CORTEZ PIPELINE GOLD DEPOSIT

Final Environmental Impact Statement – Volume II

VOLUME II - RESPONSE TO COMMENTS
**INTRODUCTION
RESPONSE TO COMMENTS**

Figure 1 - Cumulative Effects of Open Pit Mining in the Humboldt River Basin.

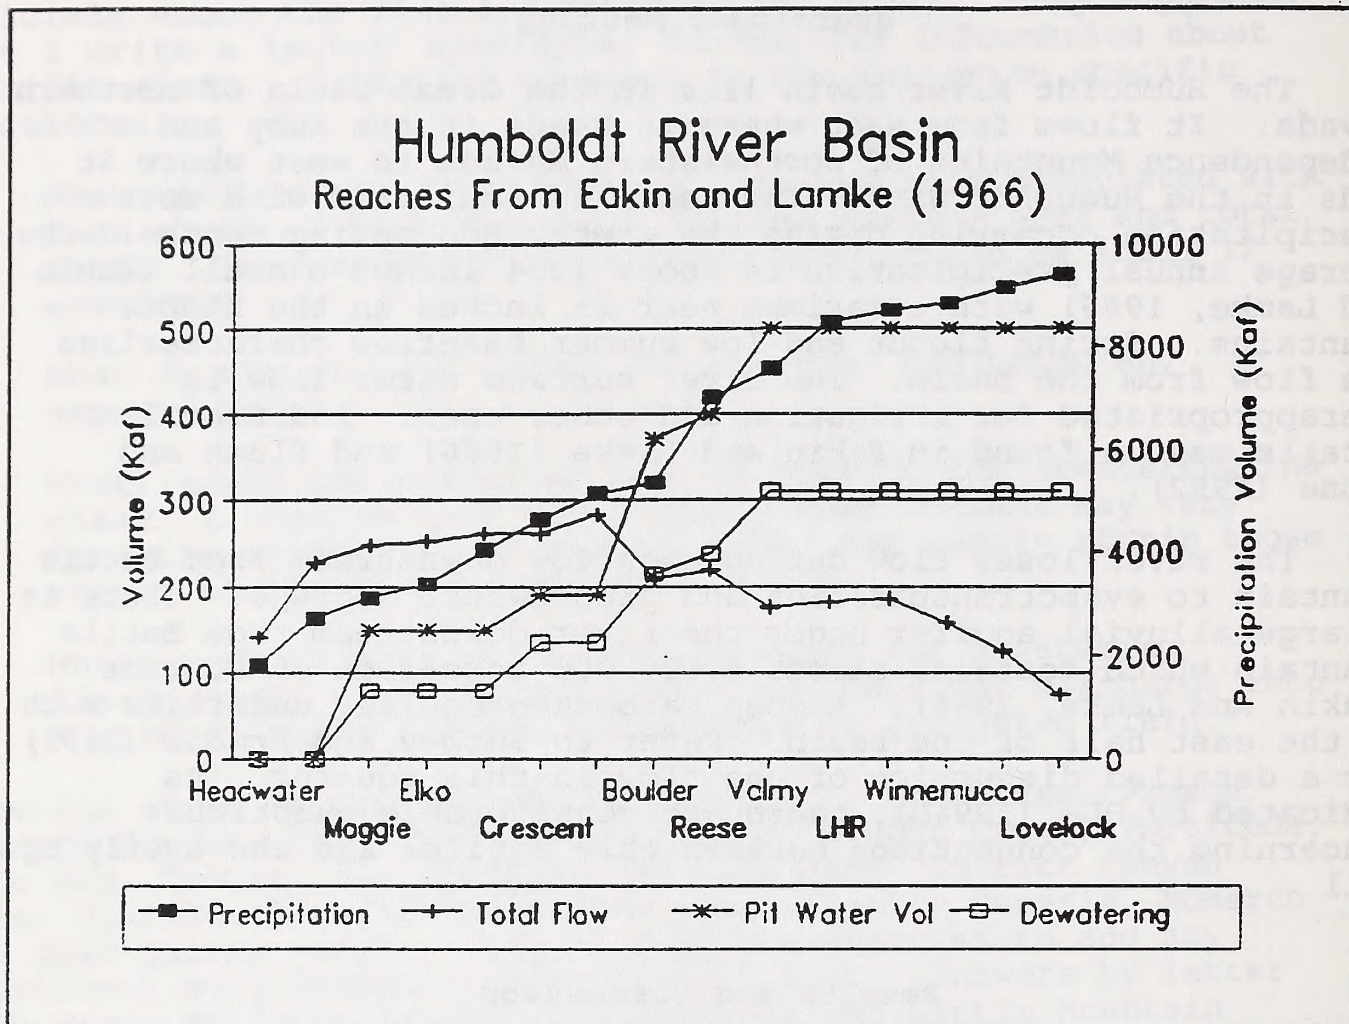
Tables 1 and 2 and Figure 1 summarize the results of this investigation. Table 1 summarizes the physical parameters of individual mines in the Humboldt River basin. Table 2 summarizes the basin water balance with cumulative effects of mines in each basin. Figure 1 provides a graphical analysis of the cumulative effects through the basin.

Figure 2 - Comparison of the Rates of Pit Recovery. See Table 3 for a description of the scenarios.

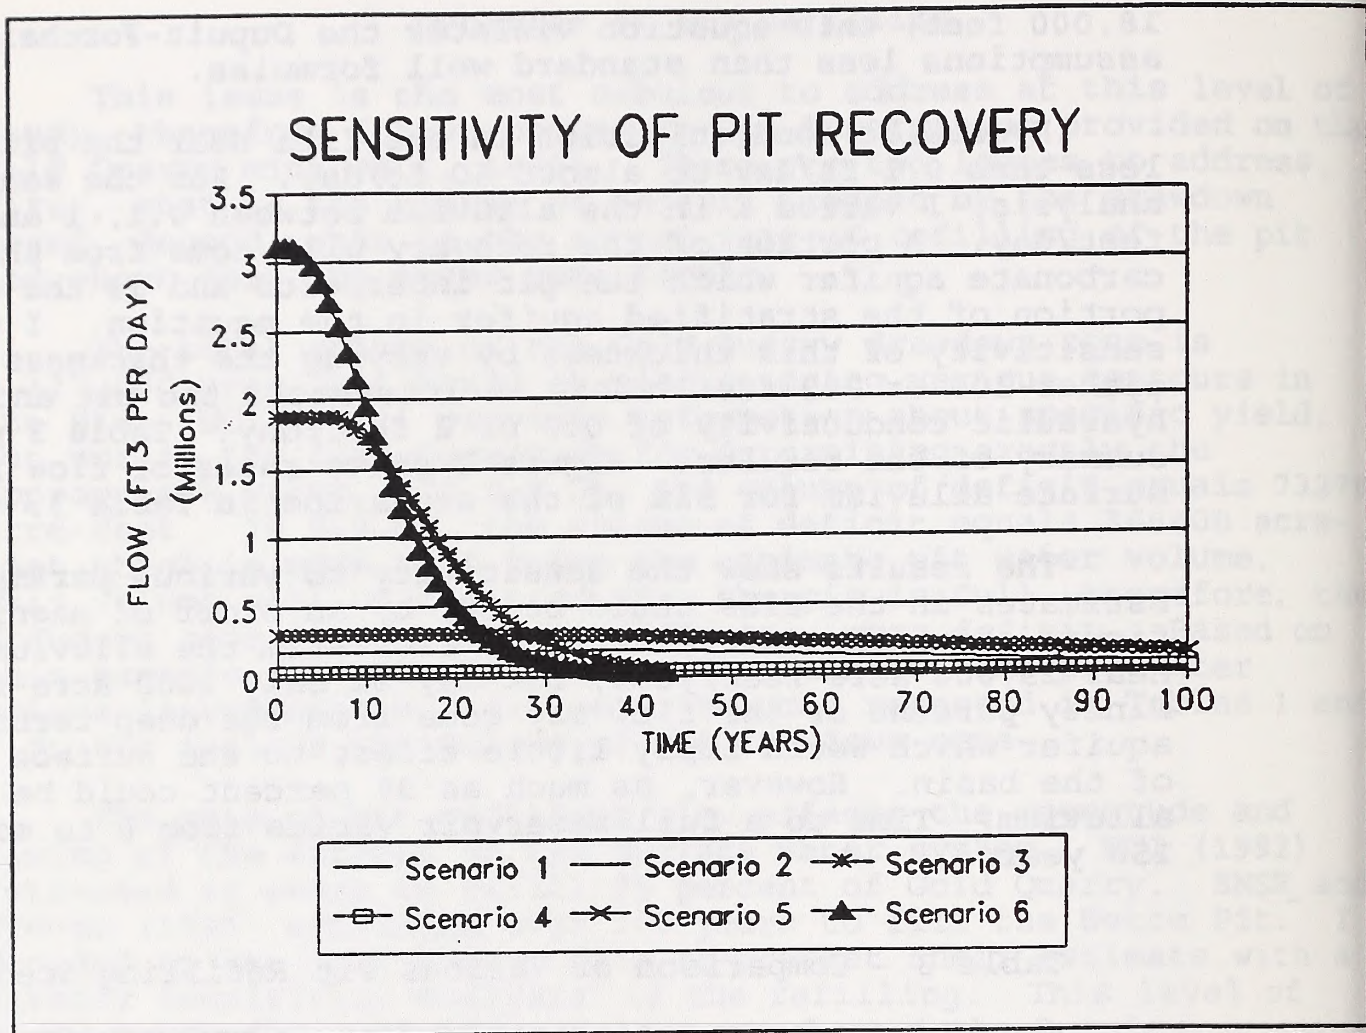
Hydraulic conductivities in the fill near the pit vary from less than 0.1 ft/day to almost 60 ft/day. For the sensitivity analysis, I varied K in the alluvium between 0.1, 1 and 10 feet/day. A portion of the recovery will come from the deep carbonate aquifer which the pit intersects and is the lower portion of the stratified aquifer in the equation. I tested sensitivity of this thickness by varying the thickness between either 100 or 300 feet where it intersects the pit and a hydraulic conductivity of 0.2 or 2 feet/day. Table 3 provides a summary of the results. Figure 2 shows rates of flow from the surface alluvium for six of the scenarios in Table 3.
